## Technical product information

<b>Topic</b>	Rear doors do not fully open (Left and/or Right) Or the soft close function is not operating to specification
<b>Market area</b>	Australia E04 Bentley rest Asia and Australia (6E04),China 723 Volkswagen (Anhui) Automotive CO (6723),China 796 VW Import Comp. Ltd (Vico), Beijing (6796),Germany E02 Bentley rest Europe (6E02),Japan E03 Bentley Japan (6E03),Korea, (South) E08 Bentley South Korea (6E08),United Arab Emirates E06 Bentley Middle East and Africa (6E06),United Kingdom E01 Bentley UK (6E01),United States E05 Bentley USA and rest America (6E05)
<b>Brand</b>	Bentley
<b>Transaction No.</b>	2068866/4
<b>Level</b>	EH
<b>Status</b>	Approval
<b>Release date</b>

### Bentayga EWB

### Revision history TPI 2068866/4

Figure 1

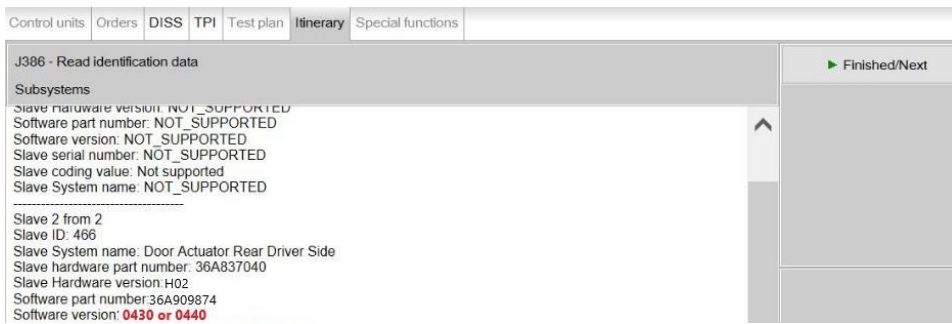
- The Software version criteria has changed as detailed below and Figure 1 **Hint:** Previously it was 0430 version only now the criteria is **0430 or 0440**
- The software update (0450) addresses an issue relating the soft close function
- The SVM code has now been changed to **4V1RDOOR02**

In the event the software version is **0430 or 0440** (Figure 1) the operative MUST raise a Technical DISS query stating the following:

- The software version of J386 and J387 is **0430 or 0440**
